Proposal for amendments to the 04 series of amendments to UN Regulation No.41 (Noise of L3 category of vehicles)

The text reproduced below was prepared by the expert from the International Motorcycle Manufacturers Association (IMMA) to amend UN Regulation No. 41-04 Supplement 8, in order to correct some references. The modifications to Regulation No. 41 are marked in bold for new or strikethrough for deleted characters.

Model A

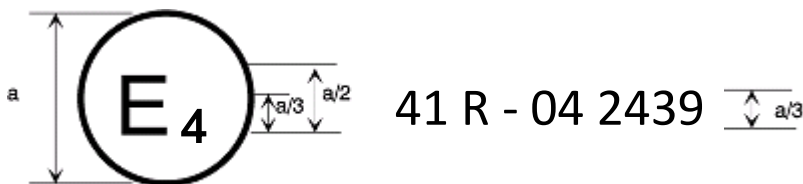
(See paragraph 5.4.5.5. of this Regulation)

- a) Paragraph 5.4.1 shall be renumbered as paragraph 5.5.1.
 - b) Paragraphs 5.4. and 5.5. shall be respectively renumbered as paragraphs 5.5. and 5.6.
-
